Amendments to the Drawings:

Applic. No.: 10/689,671
Amdt. Dated June 20, 2005
Reply to Office action of December 20, 2004

Fig. 2A

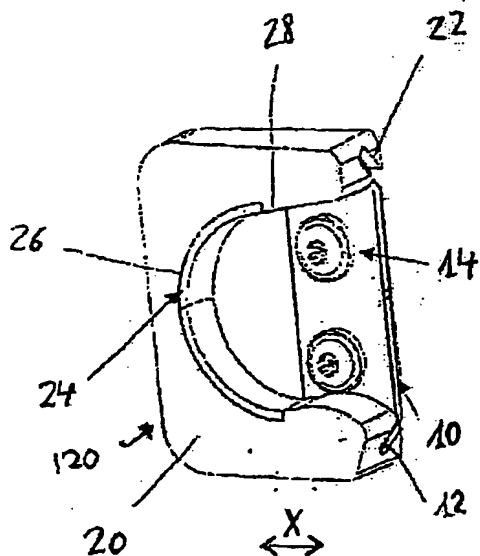
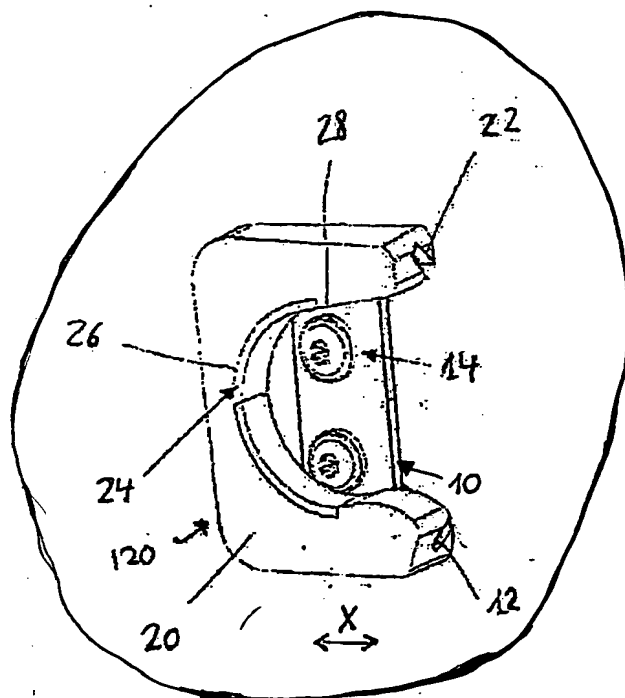
In item 1 on pages 2-3 of the above-identified Office action, the drawings have been objected to under 37 CFR 1.83(a) as not showing every feature of the invention specified in the claims.

More specifically, the Examiner has stated that the "roller receiving part which is adjustable relative to the second base plate" must be shown or the feature(s) cancelled from the claim(s).

The attached sheet of drawings includes changes to original Fig. 2. This sheet which includes Figs. 1, 2A, 2B, and 3, replaces the original sheet including Figs. 1-3. More specifically, Fig. 2 has been replaced by Figs. 2A and 2B.

Fig. 2 has been replaced with Figs. 2A and 2B to clearly show that the roller receiving part 20 is adjustable relative to the second base plate 10 (see page 6, lines 12-14 of the specification). The specification has been amended accordingly.
